DEPARTMENT OF TRANSPORTATION

STANDARD DRAWINGS

February 3, 1993

SUBJECT: Revisions to Construction Standards

DESIGN APPROVED	STATE OF ARIZONA DEPARTMENT OF TRANSPORTATION DIVISION OF HIGHWAYS STANDARD DRAWINGS	REV. 1/93
APPROVED FOR DISTRIBUTION	SIDEWALK RAMP TYPE I	DRAWING NO. C-05.30 Sheet 1 of 4

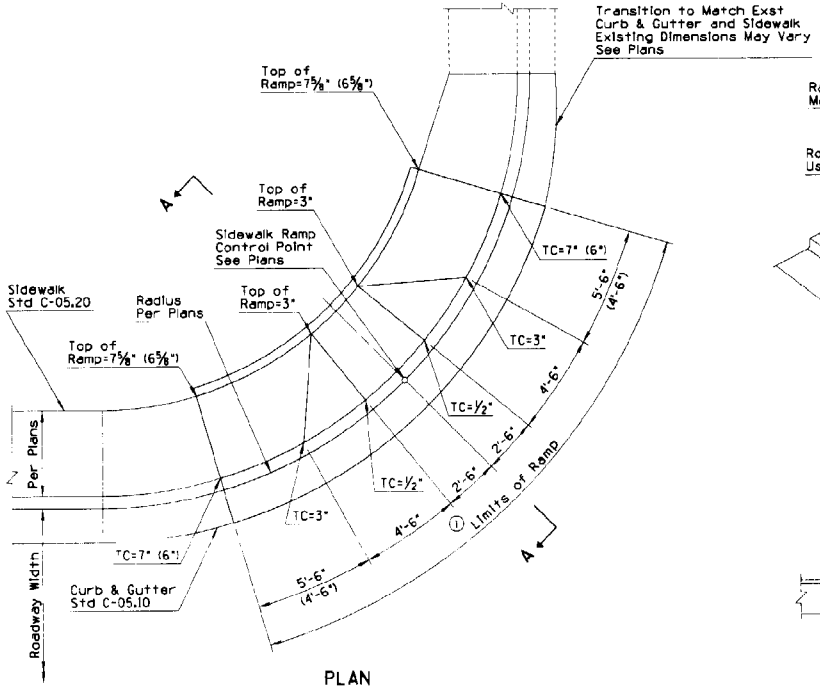
NO	DESCRIPTION OF REVISIONS	MADE BY	DATE
1	MODIFIED DIMENSIONS	TC	1/93
2	ADDED GROOVE DETAIL	TC	1/93
3	ADDED RAMP CURB	TC	1/93
4

DESIGN APPROVED	STATE OF ARIZONA DEPARTMENT OF TRANSPORTATION DIVISION OF HIGHWAYS STANDARD DRAWINGS	REV. 1/93
APPROVED FOR DISTRIBUTION	SIDEWALK RAMP TYPE 2	DRAWING NO. C-05.30 Sheet 2 of 4

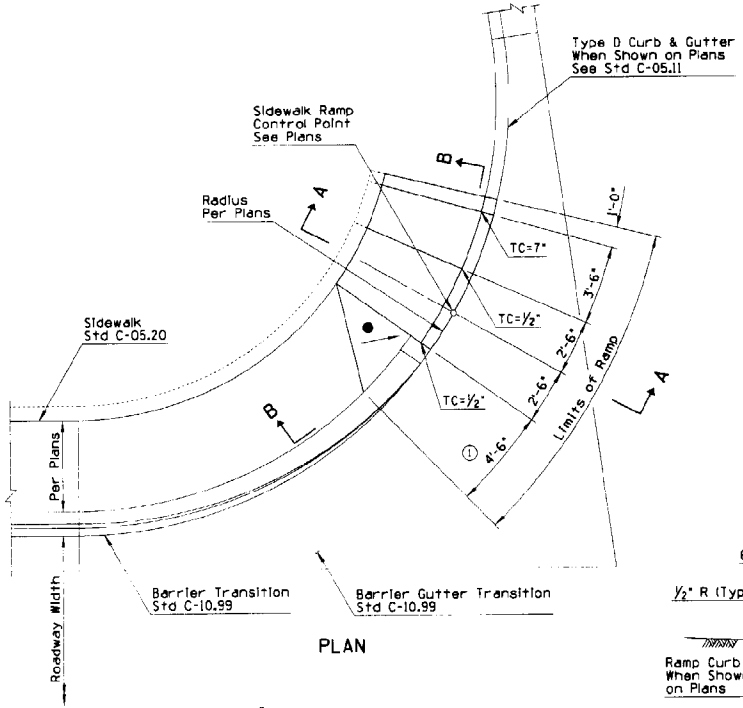
3	ADDED CURB OPTION	TC	1/93
4	ADDED GROOVES	TC	1/93

DESIGN APPROVED	STATE OF ARIZONA DEPARTMENT OF TRANSPORTATION DIVISION OF HIGHWAYS STANDARD DRAWINGS	REV. 1/93
APPROVED FOR DISTRIBUTION	MEDIAN PAVING AND NOSE TRANSITION	DRAWING NO. C-05.40

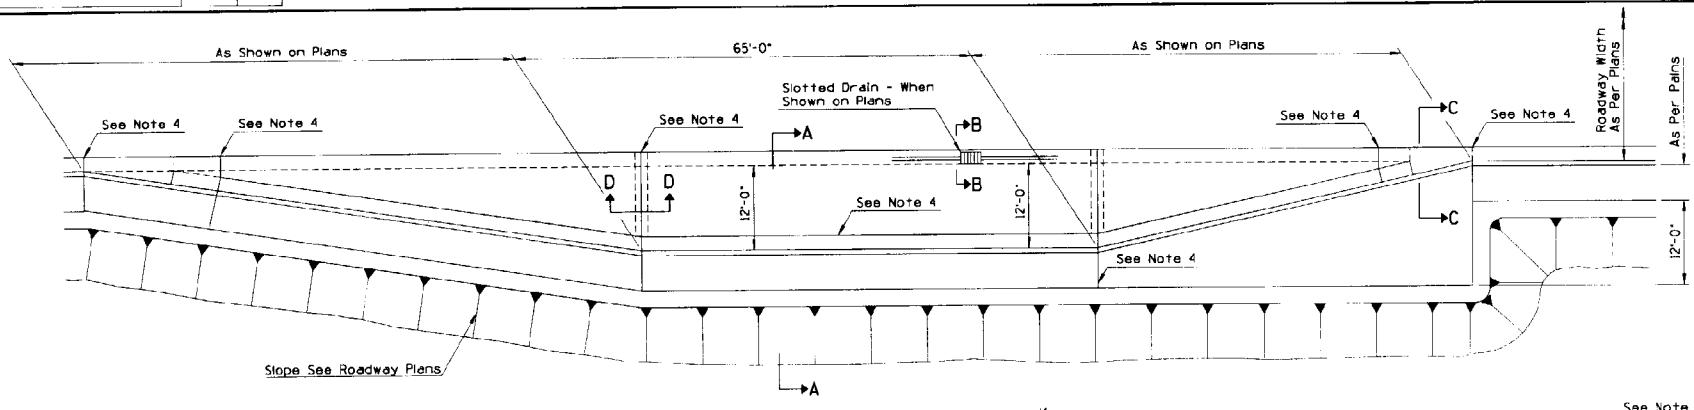
NO	DESCRIPTION OF REVISIONS	MADE BY	DATE
1	MODIFIED DIMENSION	TC	12/90
2			
3			
4

TYPICAL WOVEN WIRE FENCE INSTALLATION—TYPE 1 WW SHOWN

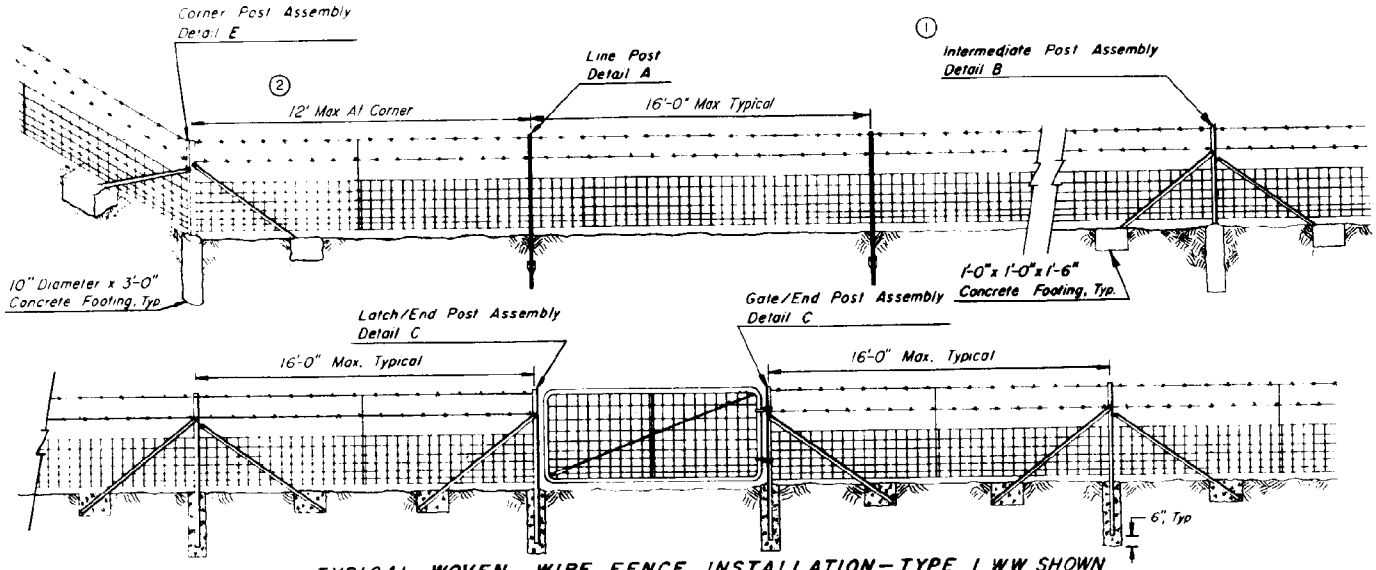
1	MODIFIED DETAIL	FM	12/90
2	MODIFIED DIMENSION	FM	12/90
3			
4

DESIGN APPROVED	STATE OF ARIZONA DEPARTMENT OF TRANSPORTATION DIVISION OF HIGHWAYS STANDARD DRAWINGS	REV.
George R. Hale		1/91
APPROVED FOR DISTRIBUTION	Fence, Chain Link Type I	DRAWING NO. C-12.20
		Sheet 1 of 3

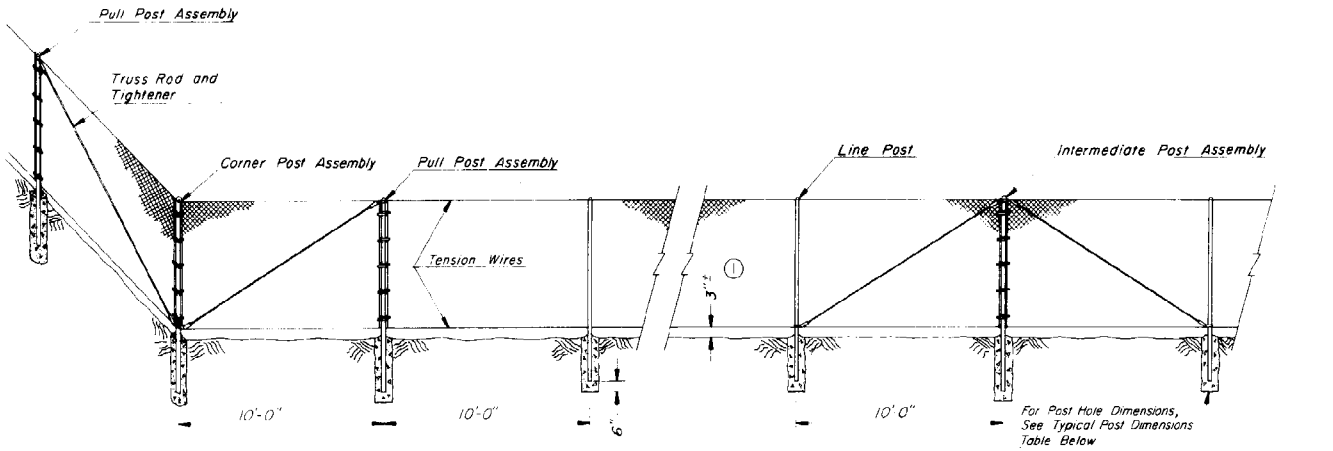
NO.	DESCRIPTION OF REVISIONS	MADE BY	DATE
1	MODIFIED DIMENSION	FM	12/90
2			
3			
4
